TOLERANCES UNLESS OTHERWISE SPECIFIED		RENKUS-HEINZ	
FRACTIONS DECIMALS		SCHEMATIC, RH23	
APPROVALS	DATE	SCALE	DRAWING NO.
CHECKER	DATE	D	
		DO NOT SCALE DRAWING	
		SHEET 1 OF 2

CONTROL CIRCUITS			
TOLERANCES UNLESS OTHERWISE SPECIFIED		RENKUS-HEINZ	
FUNCTIONAL SPEC. NUMBER		SCHEMATIC, RH23	
APPROVALS	DATE	SCALE	SIZE
DRAWN BY	DATE		D
CHECKED	DATE		
		DO NOT SCALE DRAWING	SHEET 2 OF 2

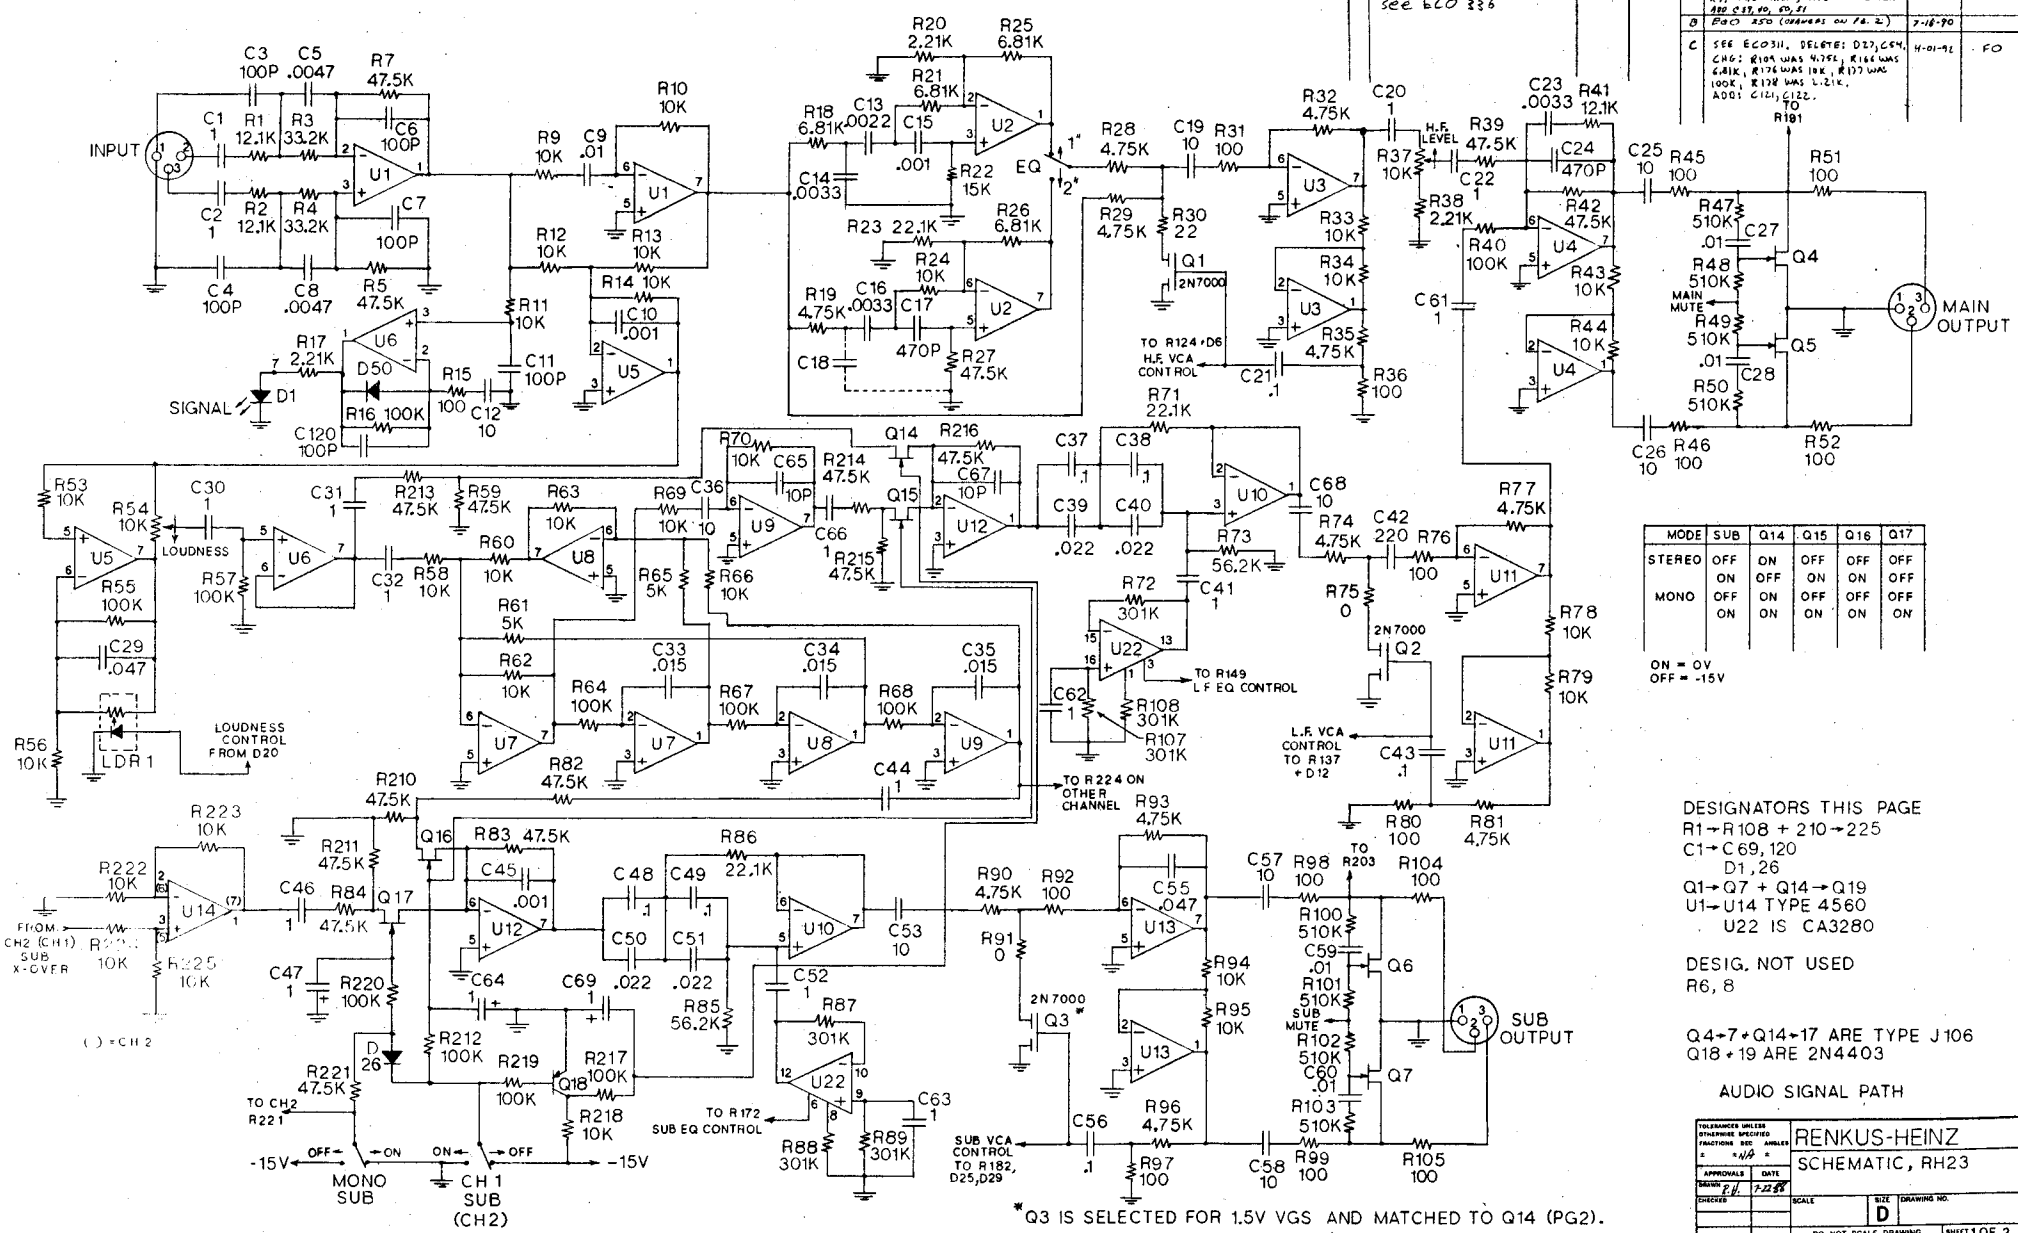
MOVED C20 FROM U3-7 to U3-1
see ECO 336

REVISIONS			
LTN	DESCRIPTION	DATE	APPROVED
A	R96 WAS 33.2K, R97 WAS 33.2K R71 WAS 47.5K, R73 WAS 56.2K R80 C19, 10, 100, 100	7-6-70	R.V.
B	R100 ASD (CONFORMS TO P.A. 2)	7-18-70	
C	SEE ECO311. DELETE: D17, C24, C46; R104 WAS 4.75K, R164 WAS 4.7K, R176 WAS 1.2K, R177 WAS 100K, R178 WAS 1.2K. ADD: C11, C12, C22.	11-01-71	FO

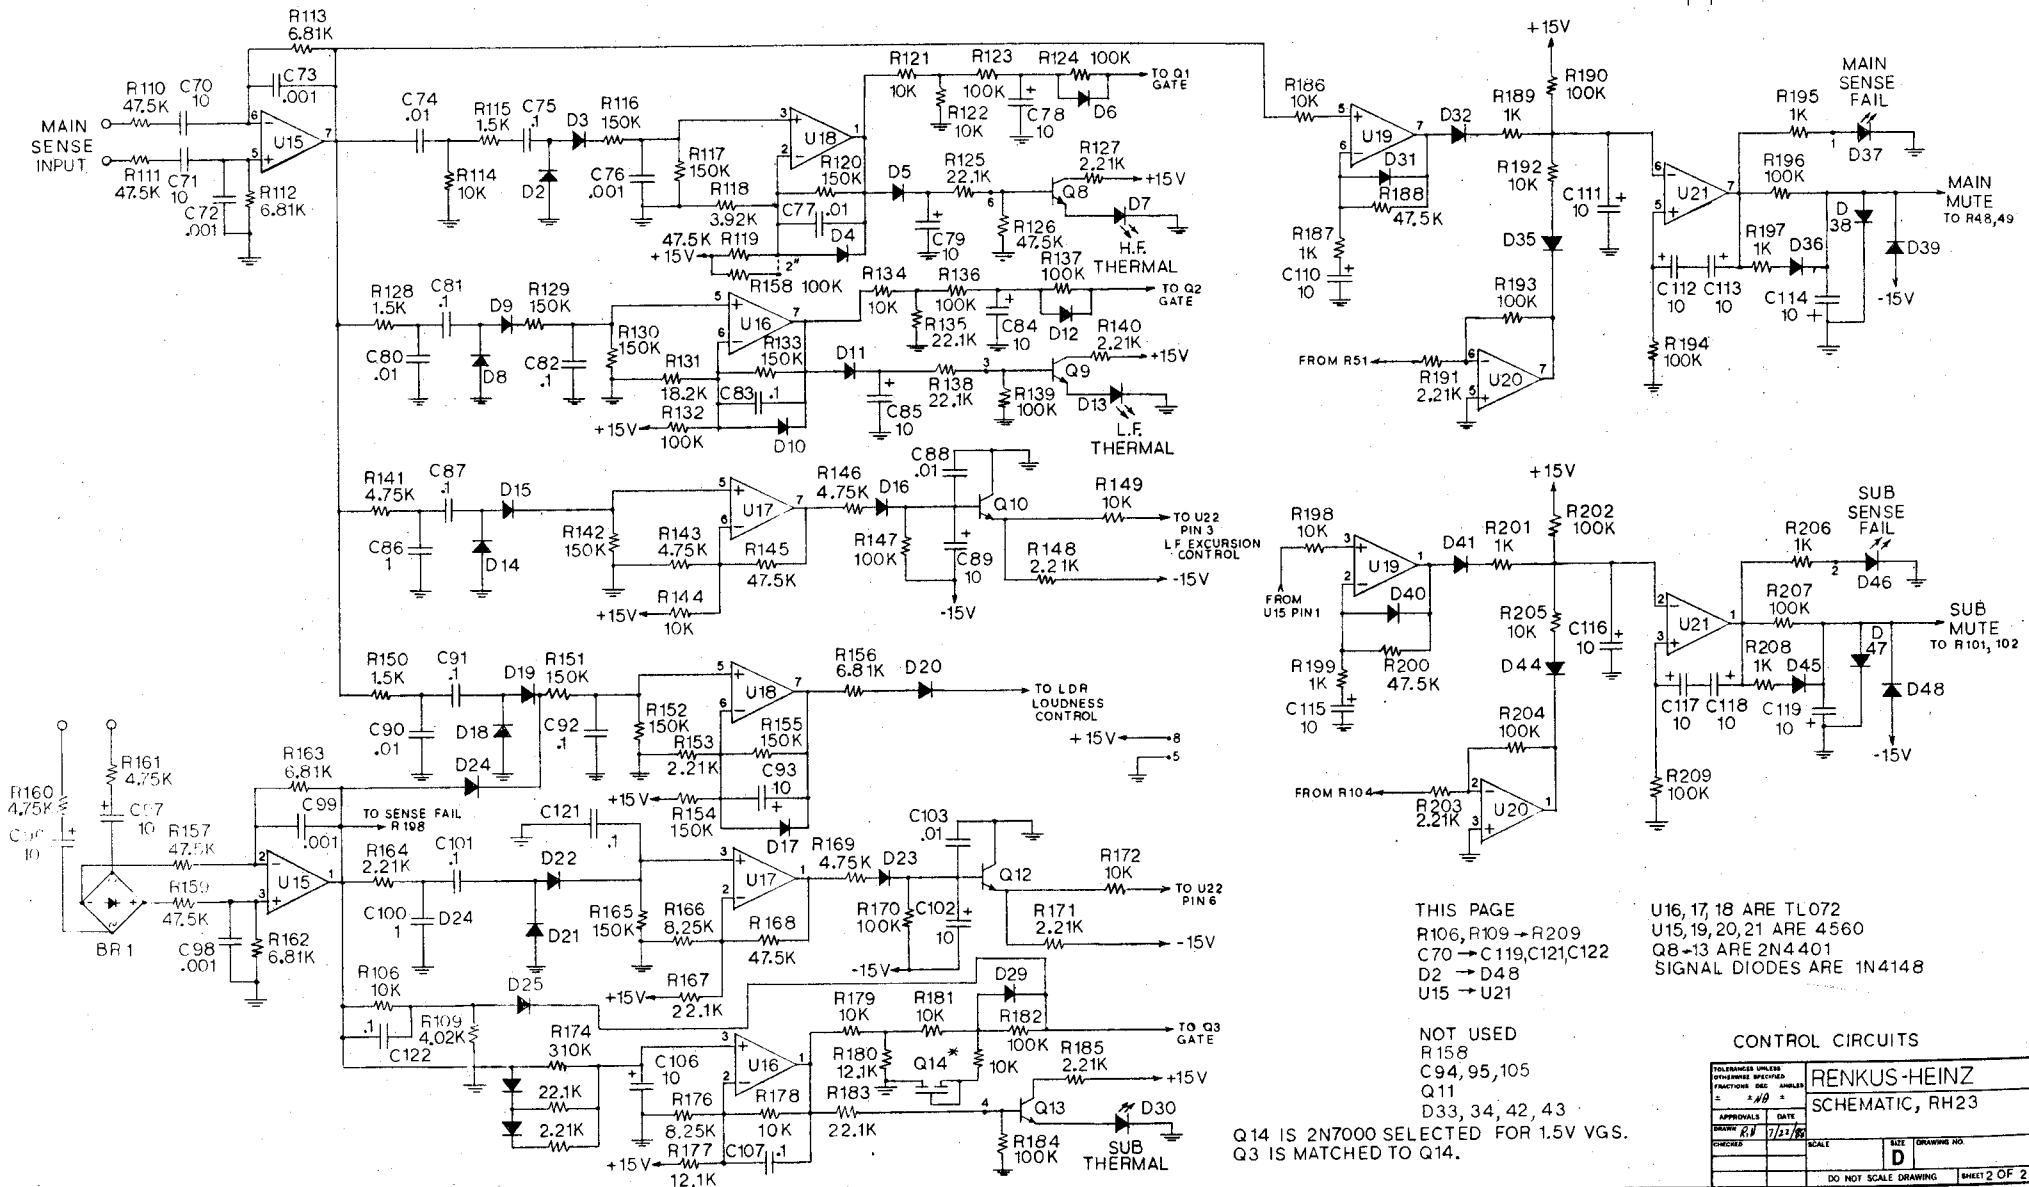
REVISIONS			
LT#	DESCRIPTION	DATE	APPROVED
A	SEE #1		
B	SEE ACO 250	7-16-70	
C	SEE PG 1	4/01/72	
D	SEE PG 1	8-3-72
